July 20, 2014

Mark Slovick
Planning and Development Services-San Diego County
5510 Overland Ave. Suite 110
San Diego, California 92123

Lilac Hills Ranch is poorly designed. Also it is not very safe. After reading the EIR concerns I have include...

FIGURE 10

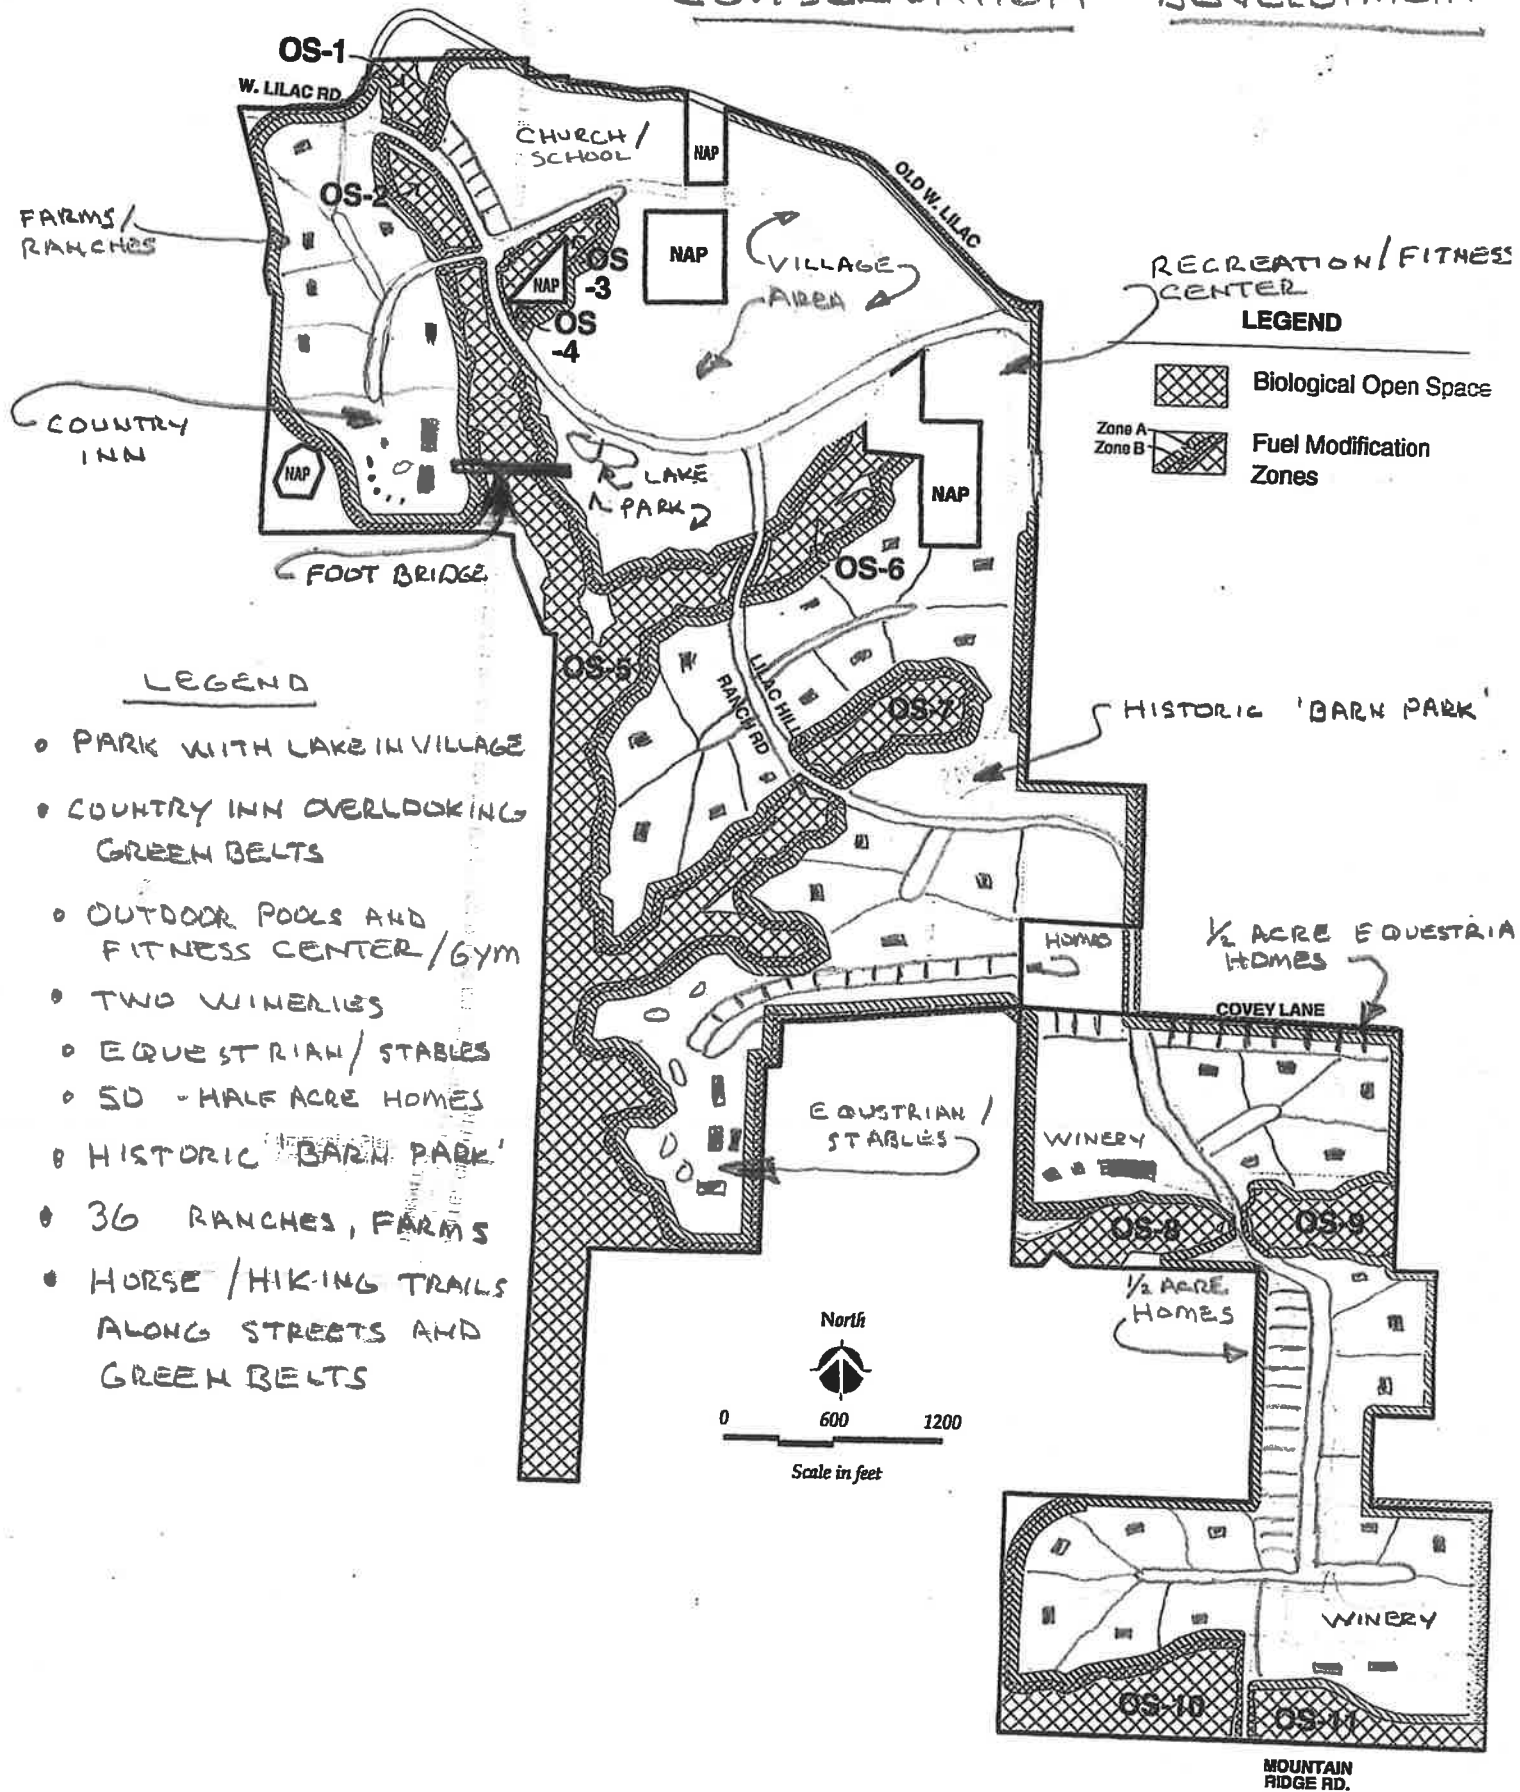
Item	No.	Subject Area	Issue, Revision or Information Required	Issue Resolution Summary (Include Conditions)	Date Identified	Date Resolved
26	49	Specific Plan	Please revise Figure 10 to remove all references to densities in the Zoning Use Regulations. For example, RU2 should be labeled as Urban Residential (RU). The figure that depicts the Zoning Boxes will be used to differentiate the different lot sizes and development regulations. A separate figure should be provided that identifies each phase or planning area and the number of dwelling units and proposed uses.		6/14/12	12/10/12
26	50	Specific Plan	The draft Specific Plan refers to areas for orchards and vineyards under the Specific Plan Summary on page II-1; however, it is unclear throughout the report where these areas		6/14/12	12/10/12
26	51	Specific Plan	The draft Specific Plan under Specific Plan Summary indicates the project proposes to make off-site infrastructure improvements to streets, trails and water and drainage facilities. No information has been provided regarding off-site improvements or whether the applicant has the ability to construct these off-site improvements. Please clarify what off-site improvements are required or proposed or delete this statement. <u>This section to be updated after acceptance of the Traffic Study.</u>	The Tentative Map and Specific Plan have been revised to indicate the required off-site improvements, including existing right-of-way or easements.	6/14/12 12/10/12 3/20/13	6/13/13
